Department of Highways

SUPPLEMENTAL SPECIFICATIONS

to the
1988 Standard Specifications
for Highways and Bridges

JUNE 6, 2006

FIGURE 1

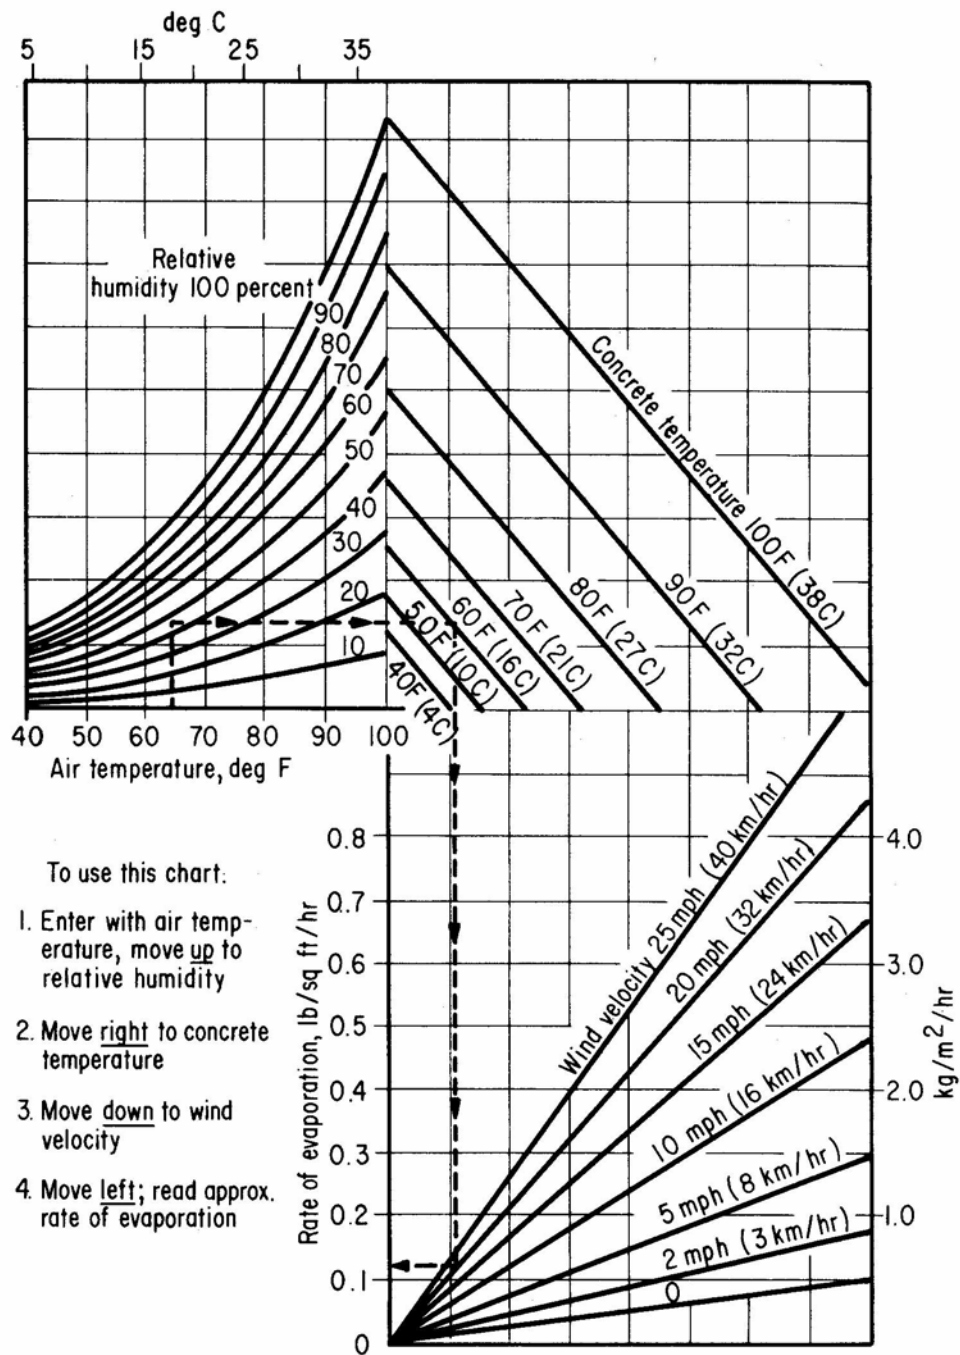
Screed rails shall be set entirely above the finished surface of the concrete and shall be supported in a manner approved by the Engineer. Where stud type shear connectors are available, welding to the studs will be permitted. Where no studs are available, other means of attaching the screed rail supports shall be provided. No welding will be permitted directly on stringer or girder flanges or cover plates in tension areas, nor in areas subject to stress reversal, for attaching either screed rail supports of any type. Any welding in compression areas shall be approved by the Engineer.

Screed rail supports set in the concrete shall be so designed that they may be removed to at least 50 millimeters below the surface of the concrete. Voids created by removal of the upper part of the screed rail supports shall be filled with mortar having the same proportions of sand and cement as that of the slab or wearing surface. The mortar shall contain an approved additive in sufficient proportions to produce non-shrink or slightly expansive characteristics. Screed rail supports shall not be treated with parting compound to facilitate their removal. Rails for finishing machines shall extend beyond both ends of the scheduled length for concrete placement. The extended length shall be of sufficient distance to allow finishing machine(s) to clear the concrete to be placed.
